Technical Bulletin

Model: P TT3			Dat	:e: 2-Jun-0	9	No.: RC274001
Subject: Parts catalog correction					d by: M.	Kumagai
From: 2nd Tech Support Sec. Service Support Dept.						
Classification:	Troubleshooting	Part info	ormat	tion	Action	n required
	Mechanical	Electric	al		Servic	ce manual revision
	Paper path	Transm	it/rec	eive	Retrof	fit information
	Product Safety	$\ensuremath{\boxtimes}$ Other ()	Tier 2

Subject: Parts information				Prepared by: M. Kumagai		
From: 1st Overseas Tech Support Sec., 1st PQM Dept.						
Classification:	Troubleshooting	Part informat	tion	Action required		
	Mechanical	Electrical		Service manual revision		
	Paper path	Transmit/rec	eive	Retrofit information		
	Product Safety	Other ()	Tier 2

Subject: New MPU board			Prepared by: K. Yamamoto		
From: 1st Overseas Tech Support Sec., 1st PQM Dept.					
Classification:	Troubleshooting	Part informat	tion	Action required	
	Mechanical	Electrical		Service manual revision	
	Paper path	Transmit/rec	eive	Retrofit information	
	Product Safety	Other ()	Tier 2

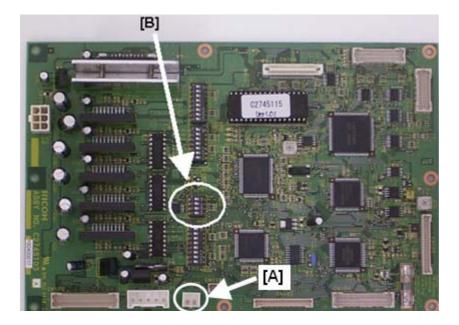
Change: The MPU board for the **TT3 (Eco model)** was changed to the one shown below. **Reason:** Parts standardization.

Note: The new board has an additional connector [A] and dip switch block [B], but these are not used when this board is installed on TT3 machines produced before this change was applied.

MPU

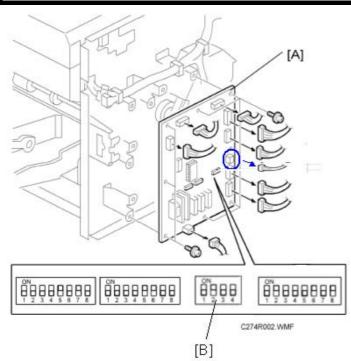
Changes:

- 1. One connector (circled in the diagram below) was added.
- 2. DIP SW 104 for auto shut-off setting was added.

[A] MPU (Screw x 8, Connector x 9)

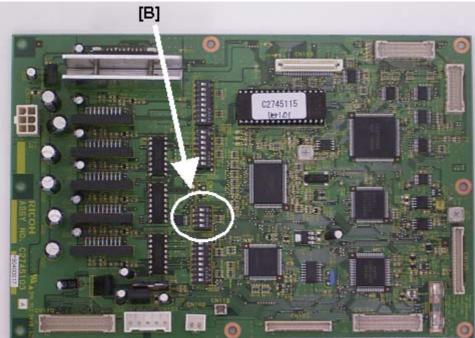
Important: The default auto shut-off setting of a brand new MPU board is OFF.

So when you replace the MPU board, you must set **DIP SW 104** to the same setting as the MPU board that you removed.

If the customer wishes to change the auto shut-off timing, change the DIP SW setting (refer to the following chart).

PSU

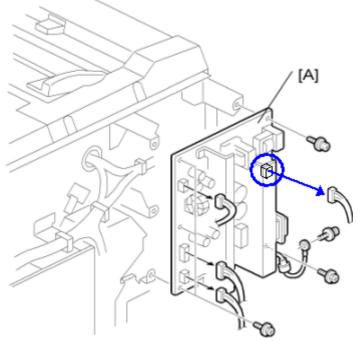
Changed: One connector was added (circled in blue in the diagram).

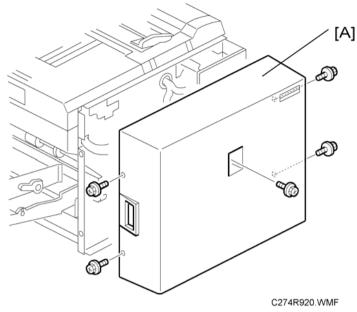
Change: The MPU board now includes the functions of the Interface board for the VC-20. **Note:**

- Because of this, the I/F board is not needed when the VC-20 is installed.
- The new Interface Kit for the VC-20 contains the harness only (it previously contained the harness + interface board).

NEW MPU board (no interface board)

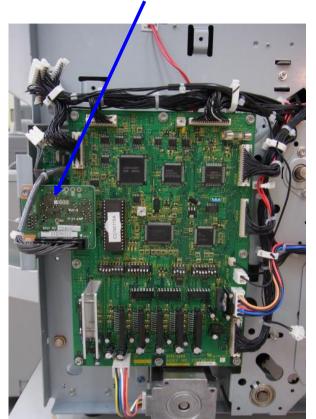
Old MPU board (with interface board)
